The amendment revises the dummy load profiles which may be used for surveillance testing of station batteries.

EDWIN I. HATCH NUCLEAR PLANT, UNIT NO. 2

Amendment No. 74
License No. NPF-5

SUPPORTING AMENDMENT NO. 74 TO FACILITY OPERATING LICENSE NO. NPF-5

Figure 3.6.2.3-1 "Dummy" Load Profiles for Station Service Batteries 2A and 2B

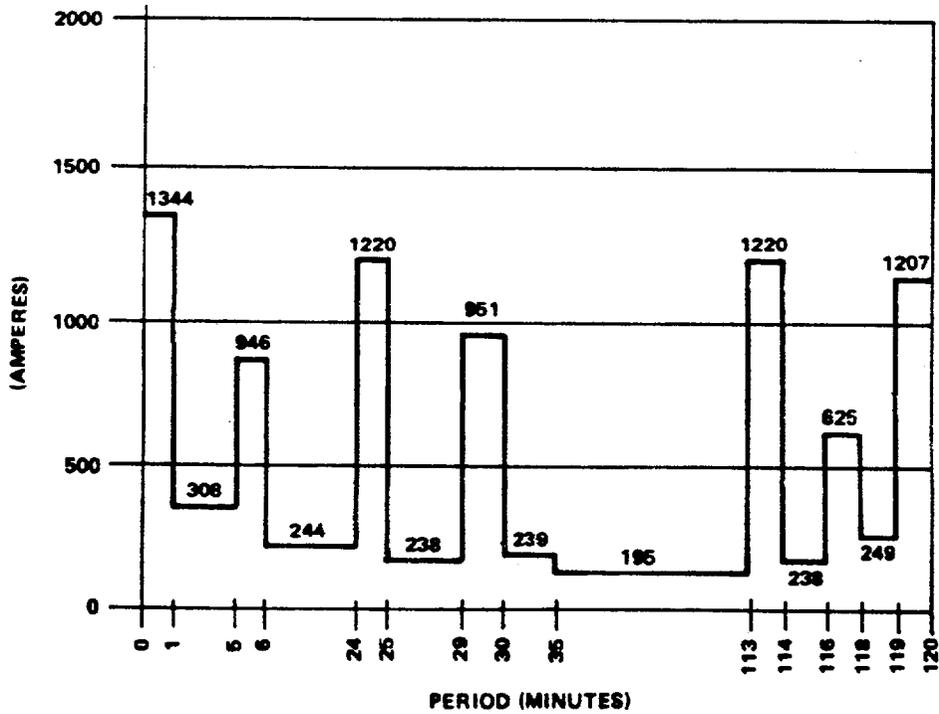
The load profile (for each battery) has been updated to reflect the as built plant. Implementation of this change will allow the use of either option for the performance of battery surveillance.

2. The battery capacity is adequate to supply a dummy load of the applicable profile given in Figure 3.8.2.3-1 while maintaining the battery terminal voltage ≥ 105 volts.
